EMERSON ONE

WATER CONSTRUCTION PLANS

CONTRACT NO. 44-4506-D

THE PURPOSE OF REDLINE REVISION #2 IS:
1. SHOW THE PROPOSED EMERSON CAMPUS SECURITY FENCE.
2. ADD AN ADDITIONAL DRAWING SHEET ASSOCIATED WITH THE PROPOSED EMERSON CAMPUS SECURITY FENCE.

WATER PROFILES

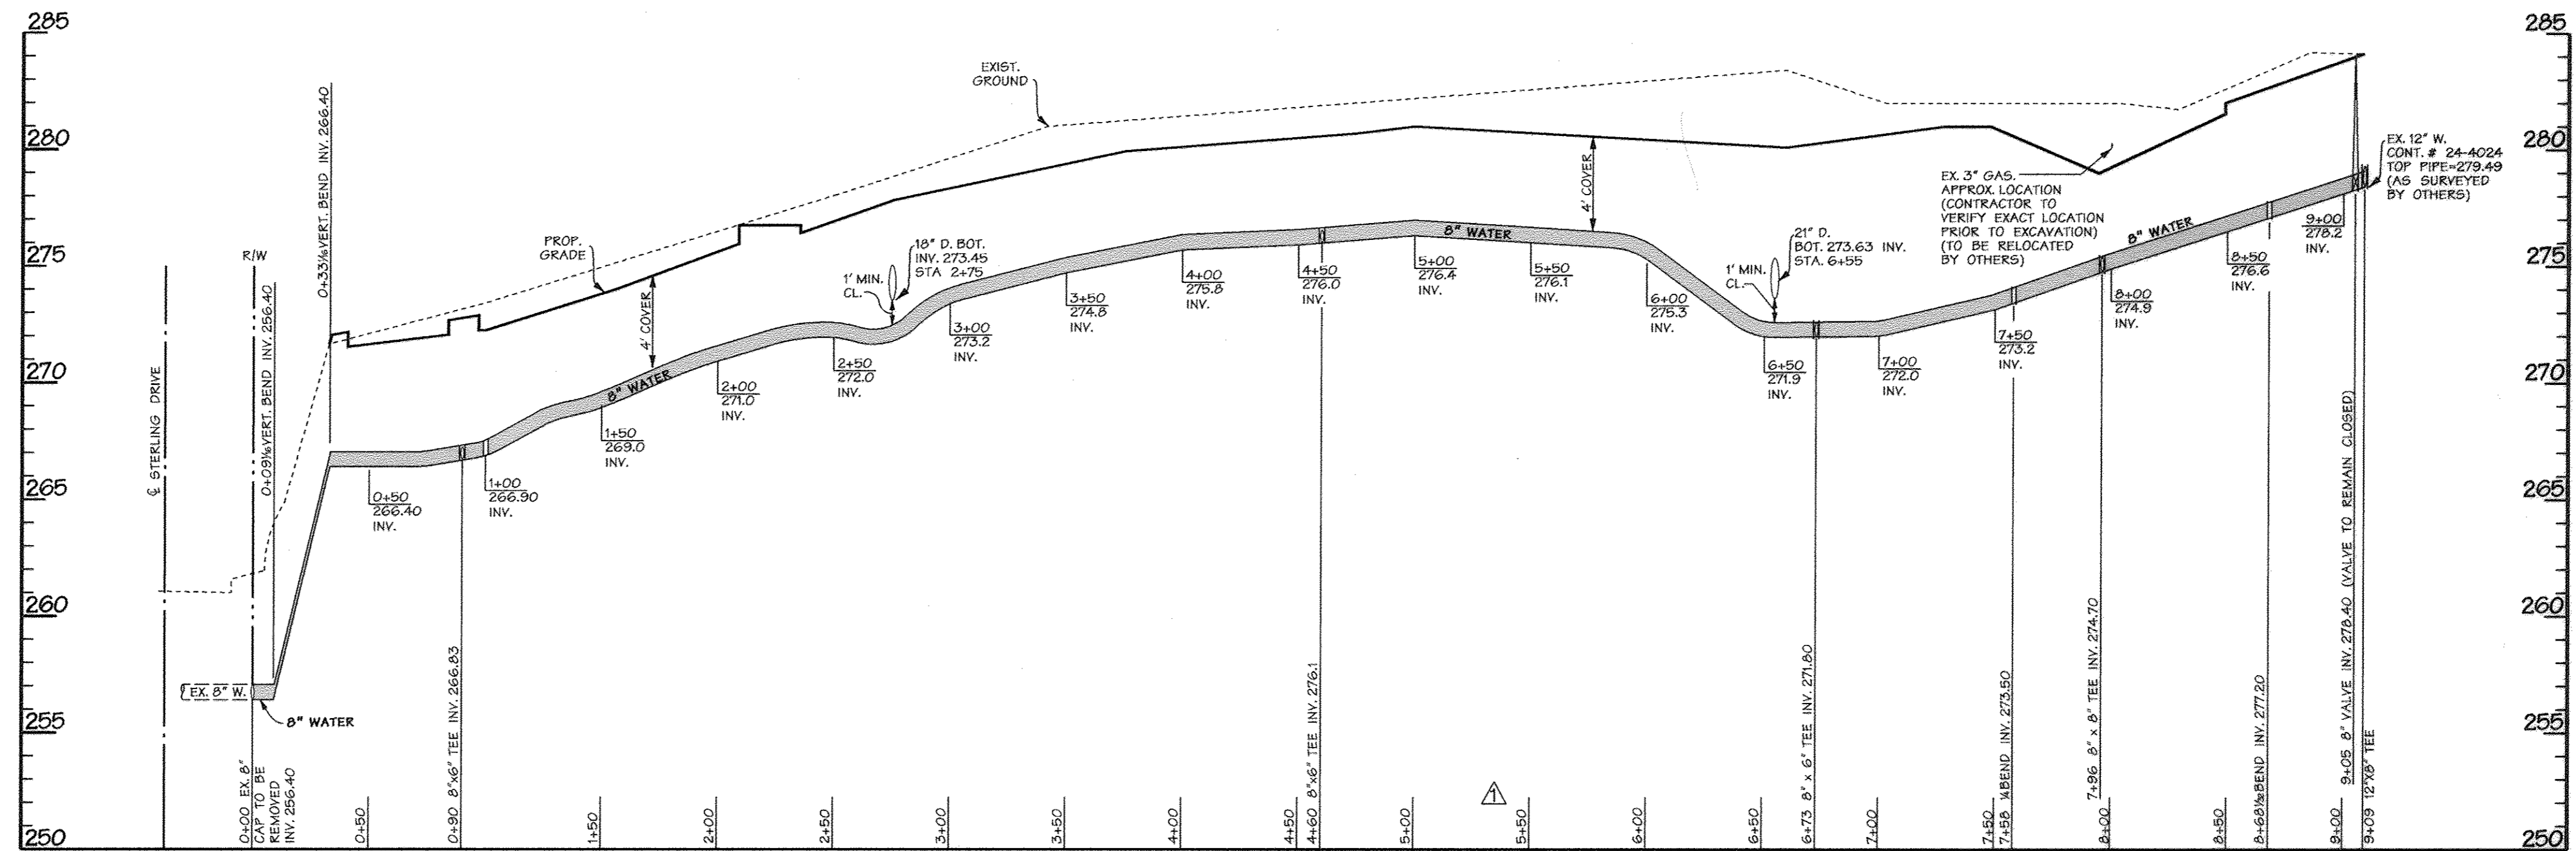
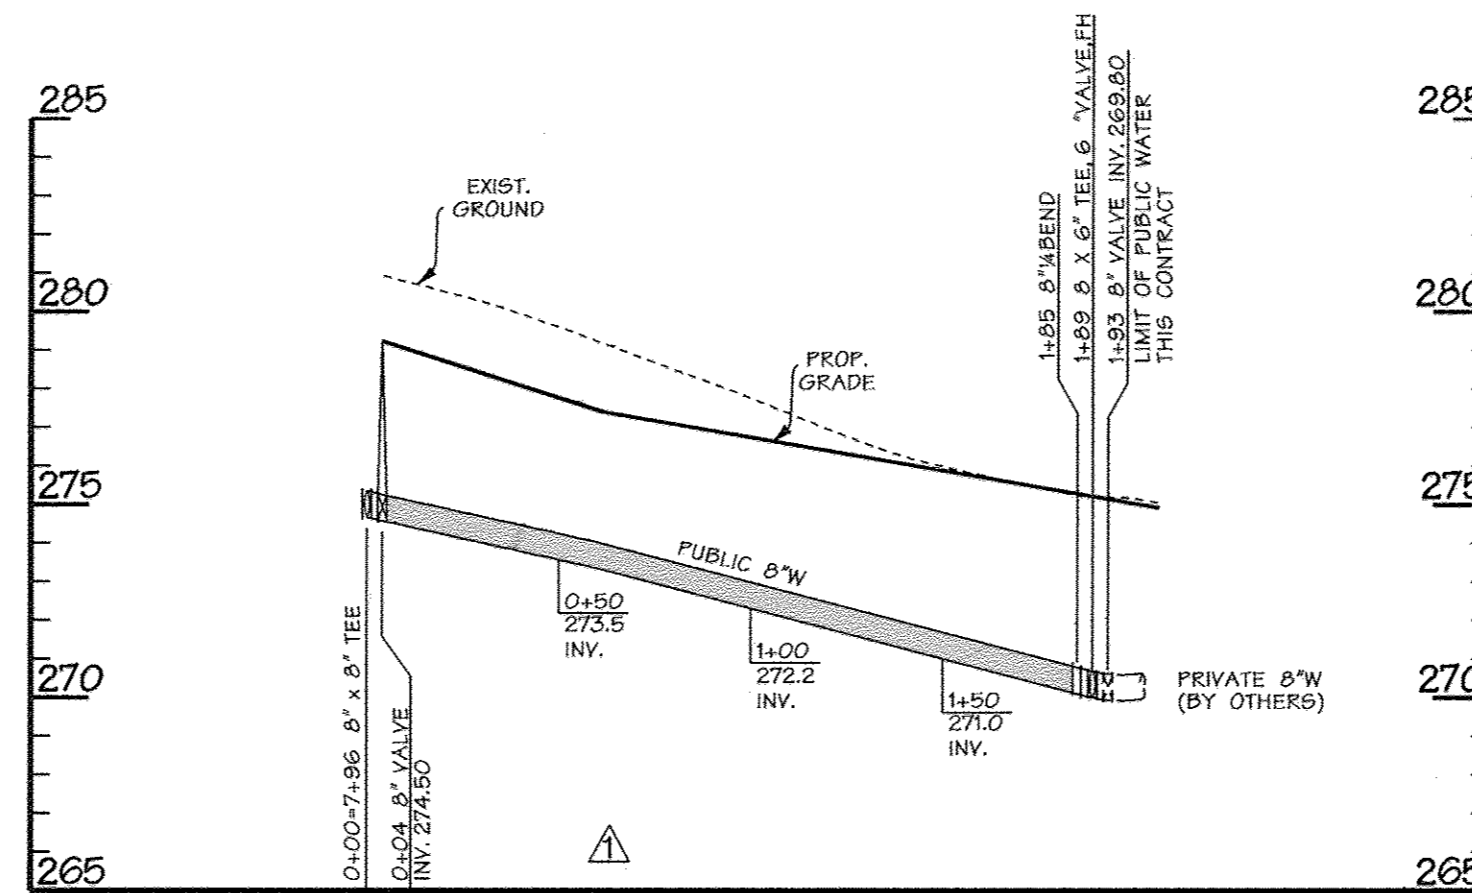
DESIGN BY:	GRG			
DRAWN BY:	JDW			
CHECKED BY:	GRG			
DATE:	3/3/08	DMW	1	PARTIAL RELOCATION DUE TO UTILITY POLE CONFLICT
		BY	NO.	REVISION
